**W2: Huebner Creek – Eckhert to Bandera
Solicitation Number: CO-00420
Job No.: 15-4513**

**ADDENDUM 2
April 20, 2021**

W2 HUEBNER CREEK: ECKHERT TO BANDERA
 SHEET
ABANDONMENT PLAN (SHEET 1 OF 2)

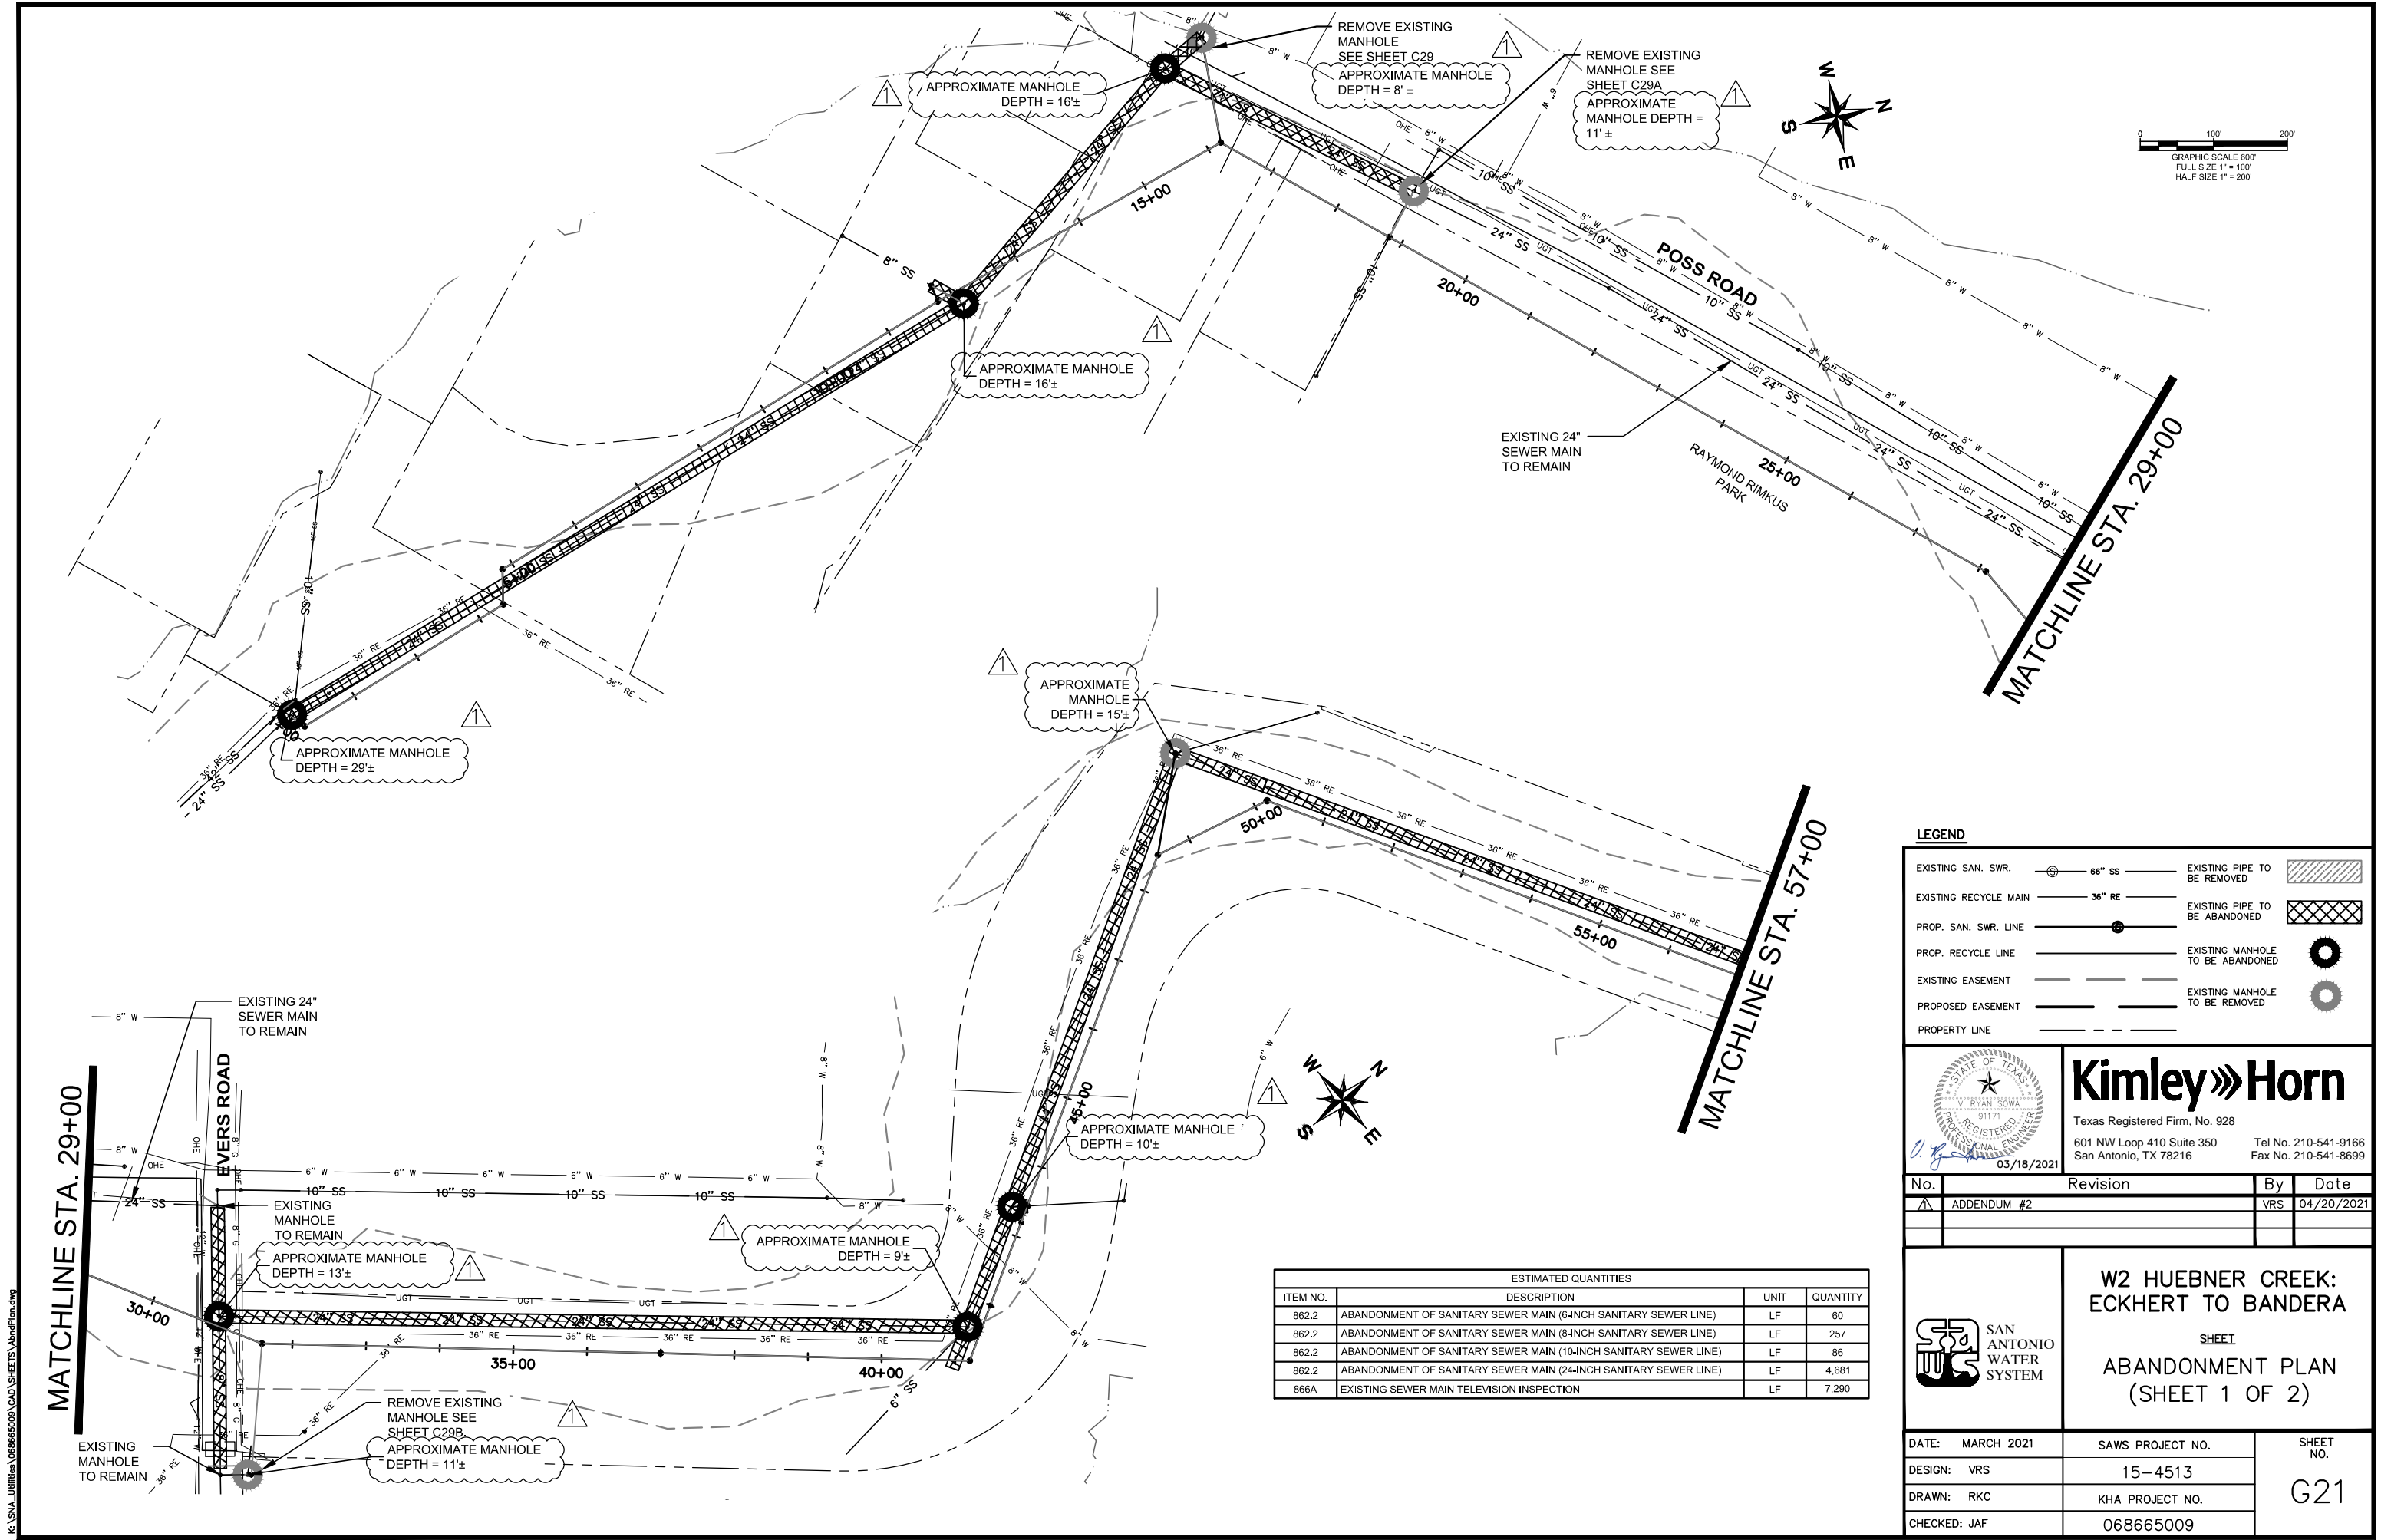
Q2: Can the depth of the existing manholes to be abandoned please be provided?

1. Remove sheet G21 and replace with G21 attached in this addendum.
2. Remove sheet G22 and replace with G22 attached in this addendum.

Response: *The Plans have been updated to identify approximate depths of existing manholes to be abandoned. Refer to the “Changes to Plans” section of this Addendum, Items 1 and 2.*
